Well Name: SALADO DRAW 29 26 33 FED COM	Well Location: T26S / R33E / SEC 29 / NWNW /	County or Parish/State: LEA / NM
Well Number: 2H	Type of Well: OIL WELL	Allottee or Tribe Name:
Lease Number: NMNM27506	Unit or CA Name: SD EA 29 32 FED STATE COM AREA	Unit or CA Number: NMNM139732
US Well Number: 300254263700S1	Well Status: Producing Oil Well	Operator: CHEVRON USA INCORPORATED

Sundry ID: 2766643

Type of Action: Temporary Abandonment

Actual Procedure: CHEVRON USA INC HAS TEMPORARILY ABANDONED THE SALADO DRAW 29 26 33 FED COM 2H (30-025-42637). THE CORRESPONDANCE IS ATTACHED BETWEEN CHEVRON AND BLM ENGINEER. 12/07/2023 TA PROCEDURE Rig up pulling unit Kill well, issues killing utilize mud to kill. Pull gas lift completion and packer RIH with gauge ring to 9175 Set CIBP at 9150' & dump bail 35'cement Well began to flow as rigging down, notify BLM and form plan. Set packer at 6110 flow up tbg only and backside tested good. Raise packer to 5498' RU coil tbg tag top of cement at 9115' then pump 136 sks Class H cement plug from 9115 to 7554' pressure test. Rig down coil Rig up pulling unit. Release PKR and pull tbg. Perform pressure test of plug to 500 psi for 30 min. Rig down pulling

Salado Draw 29-26-33 FED COM 2H

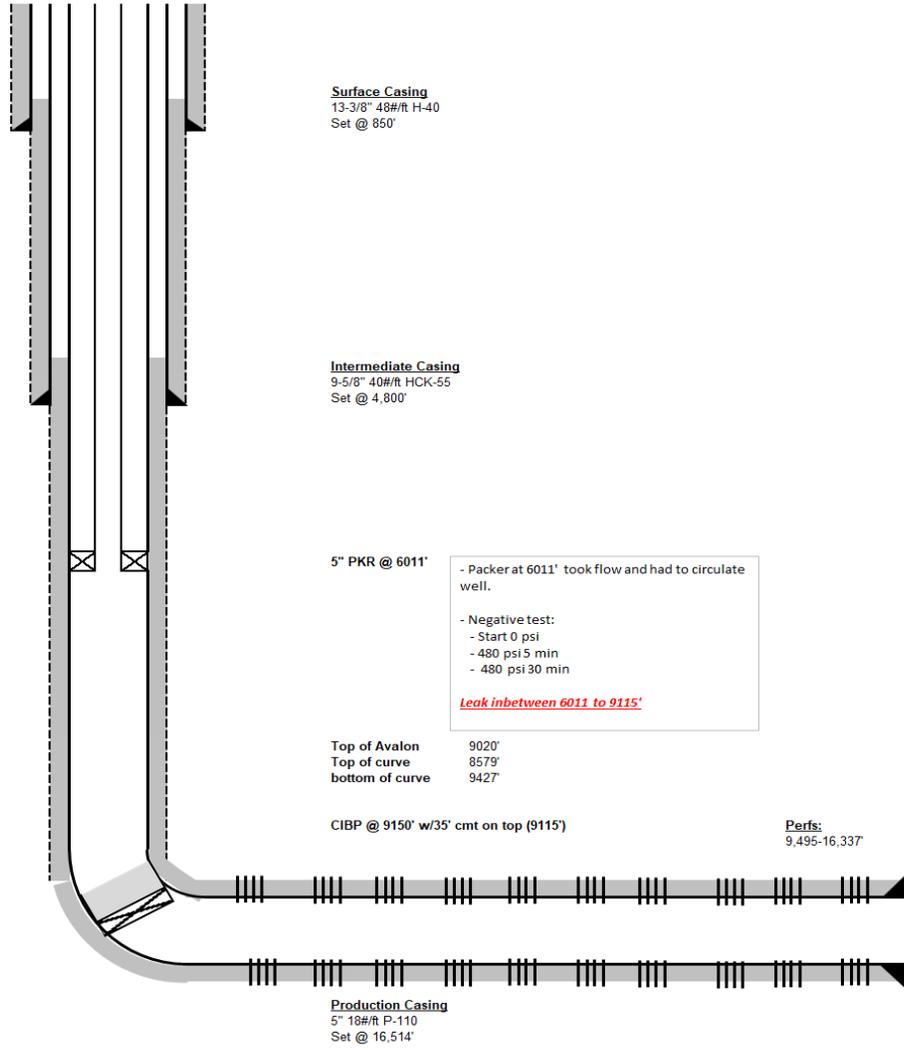
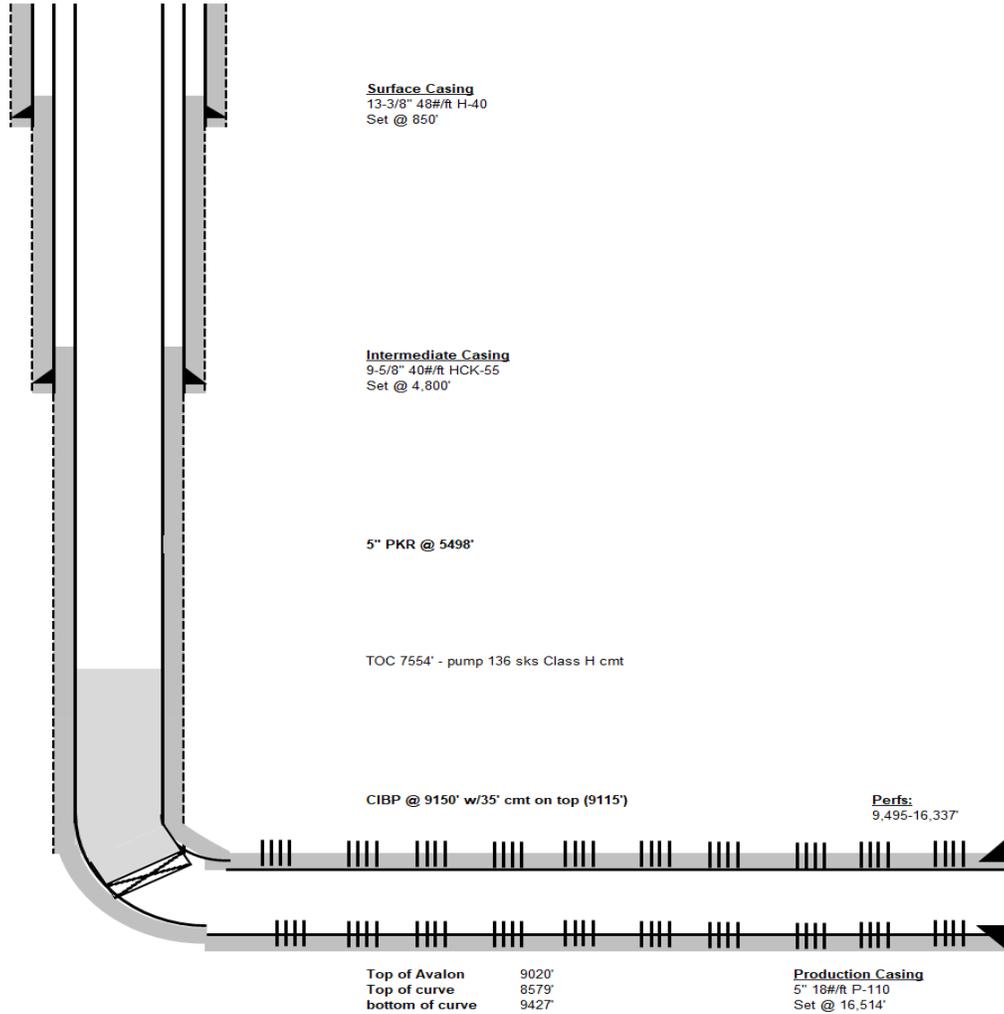
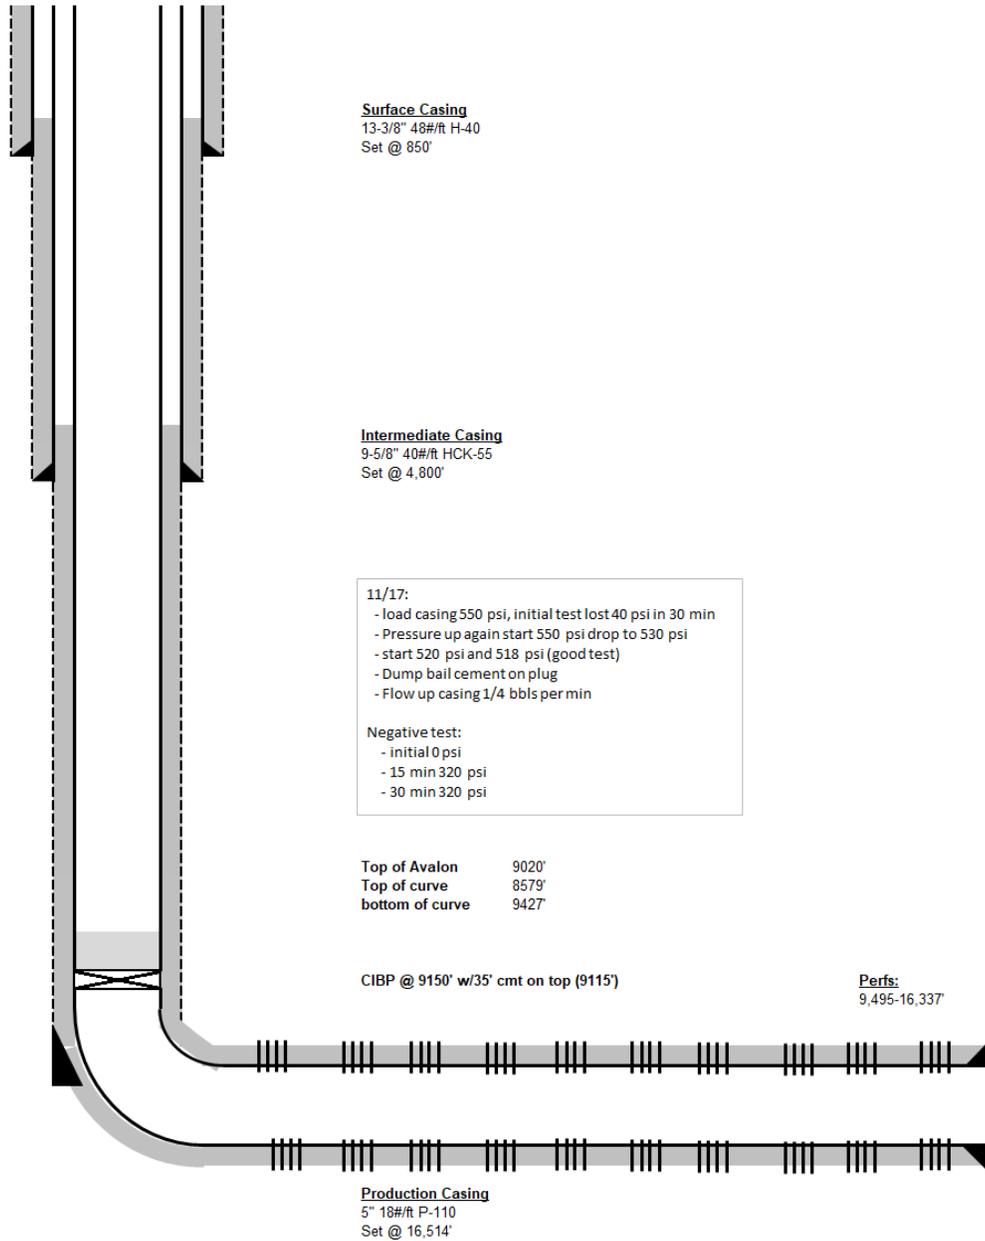
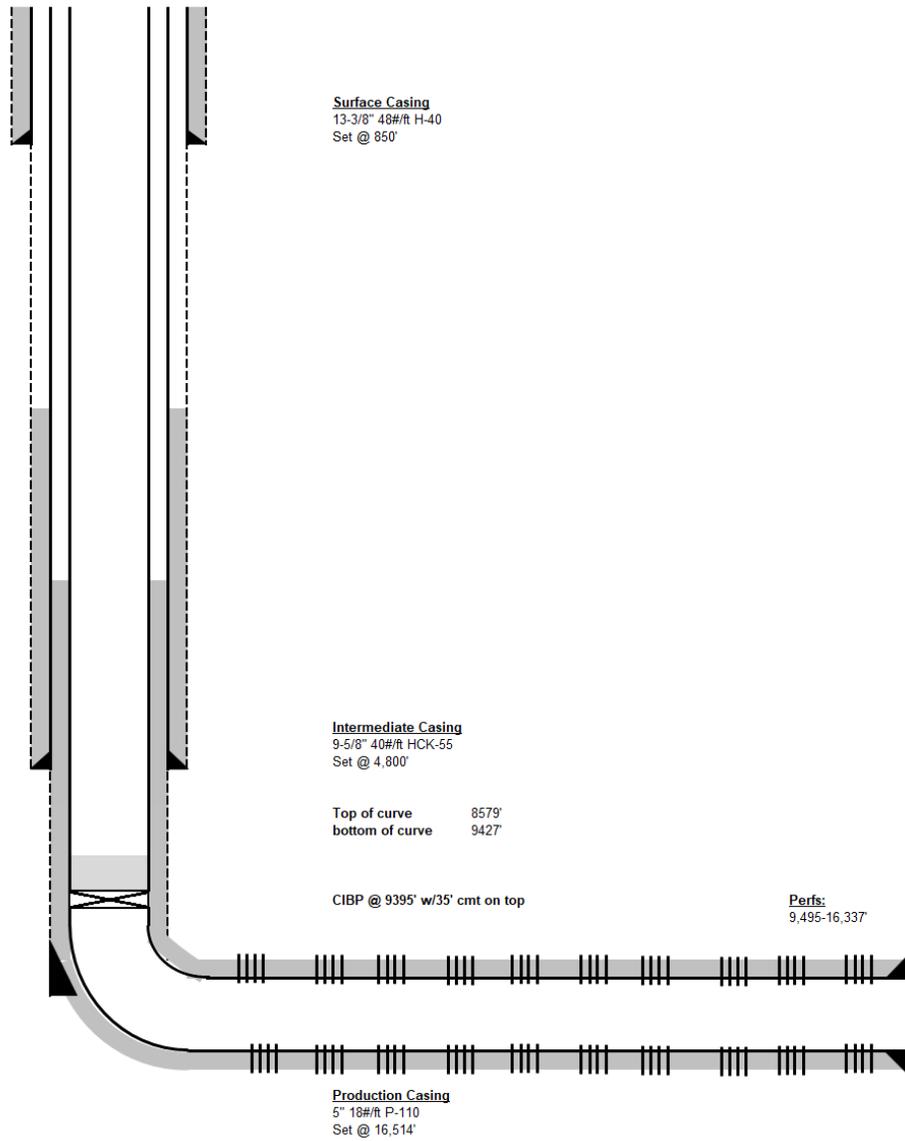
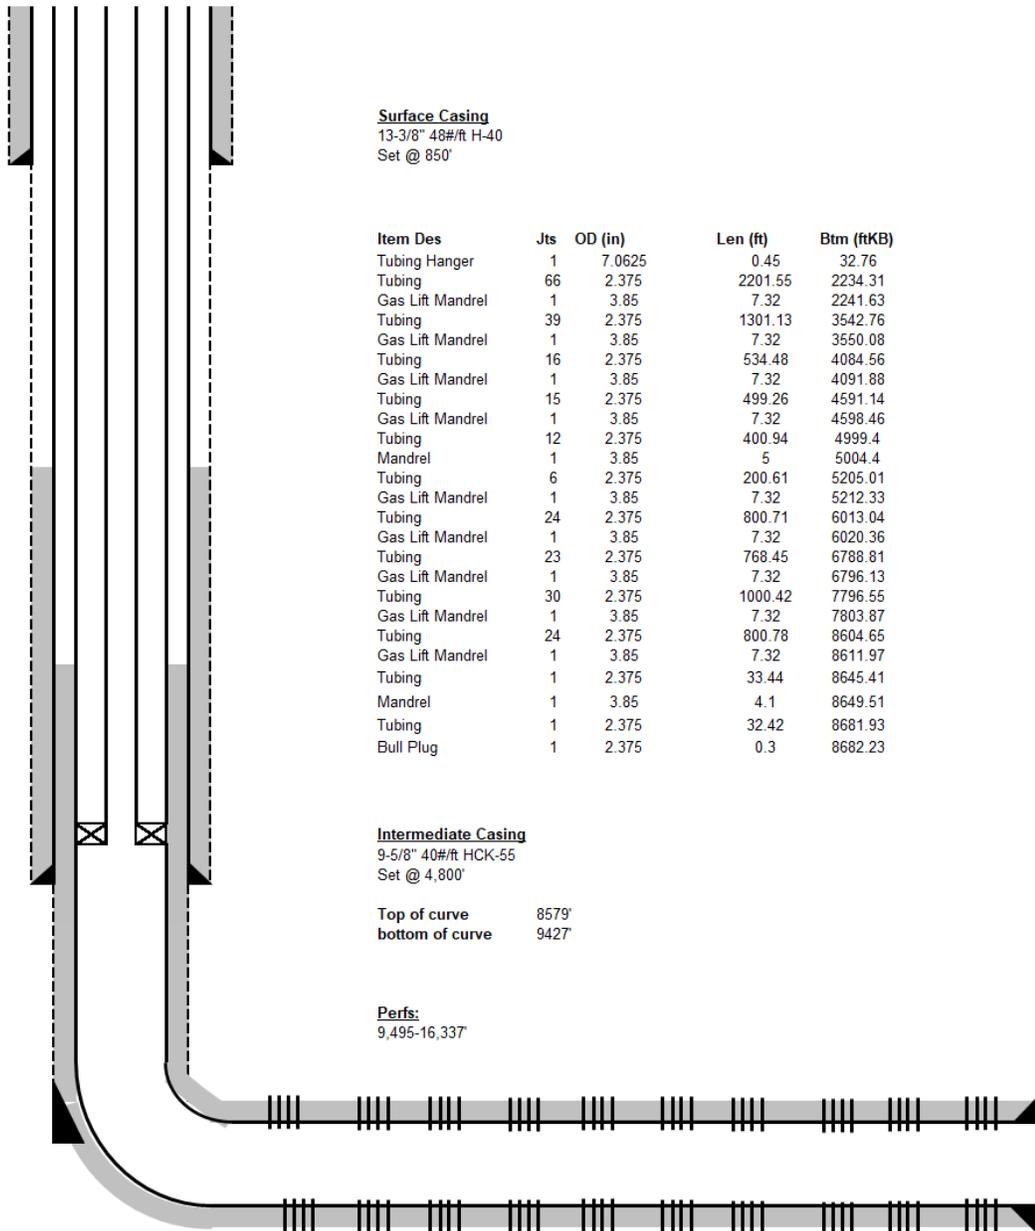
I would like to seek your feedback and approval on us setting a plug (RBP) at 6011' and if it passes pressure test we could consider this TA'd or if we could TA it with tbg and pkr in hole set at 6011'. In addition to the chart from 9150' I have included an updated WBD that has some notes to reflect current situation.

Per our phone conversation on the Salado Draw 29 26 33 FED COM 002H (30-025-42637) and plug setting depth to temporary abandon the well we are seeking to move up from top perf. Our proposed depth on Sundry was 9395' MD (9154' TVD) and we are currently able to get to 9150' MD (9079' TVD), please see attached WBD & Directional survey for more detail. In addition, I have included a table below of depths from our discussion as well. Looking at the top of the Avalon, within the Bone Spring group we show the top of reservoir 9020 (West) to 9138' (East).

During our phone conversation we had discussed setting the plug around 8759', but we can get closer to the top of Avalon formation. Would you be ok with setting the plug ~9100' and top with 35' of cement?

The BLM grants you verbal approve to proceed with the plan as proposed. Please keep me updated on the progress.

The BLM grants you verbal approve to proceed with the plan as proposed setting plug at 9100'.
